Access Compliance Report

Public Rights-of-Way

Intersection ID: 20961	Main Street: WESTINGHOUSE COMMONS DR	Cross Street: WESTLAKE DR	Location:	N
ADA ID: 02CFD0B51D7F	Ramp Type: PerpDiag	Initial Pass/Fail: Pass	Overall Compliance: No	Severity Score: 15

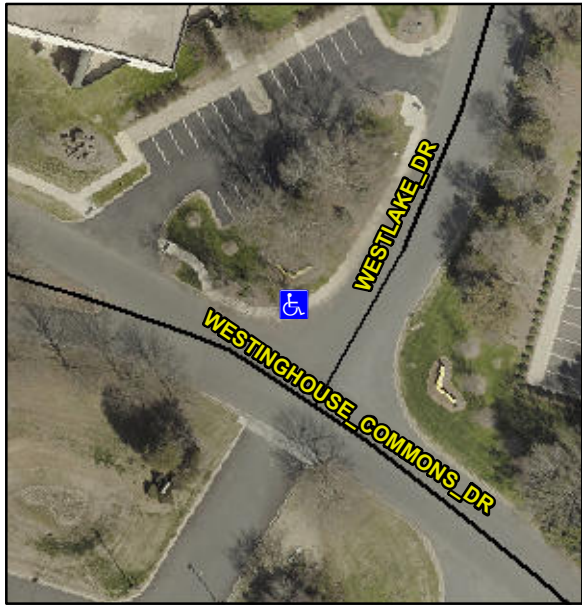
Codes/Mitigation Info/Possible Solution			Field Measurements/Component Compliance					
	Possible Solutions:		Compliance	Description	Data	Compliance	Description	Data
	Remove & Replace Curb Ramp With Two New Directional Ramps or Equivalent. Remove & Replace Gutter.		N/A	Ramp Length (in)	60.0	Yes	Ramp Slope (%)	6.3
			Yes	Ramp Width (in)	59.0	Yes	Ramp XSlope (%)	0.1
			N/A	Flare Type LT	Sloped	N/A	Flare Type RT	N/A
			N/A	Flare Slope LT (%)	3.0	Yes	Flare Slope RT (%)	4.6
			N/A	Flare Traversable LT?	Yes	N/A	Flare Traversable RT?	Yes
	Surveyor Notes:		No	Landing Length (in)	N/A	Yes	DWS Provided?	Yes
			No	Landing Width (in)	N/A	Yes	DWS Contrast?	Yes
			No	Landing Slope (%)	N/A	Yes	DWS Length (in)	24.0
			No	Landing X Slope (%)	N/A	Yes	DWS Full Width?	Yes
N/A			Landing Curb? (Y/N)	No	Yes	DWS Offset (in)	0.0	
PROW/ADA:		N/A	Shared Landing?	No				
		Yes	Gutter Ponding?	No	No	Gutter Slope (%)	8.0	
		Yes	Gutter Lip Ht (in)	0.0	Yes	Gutter X Slope (%)	0.1
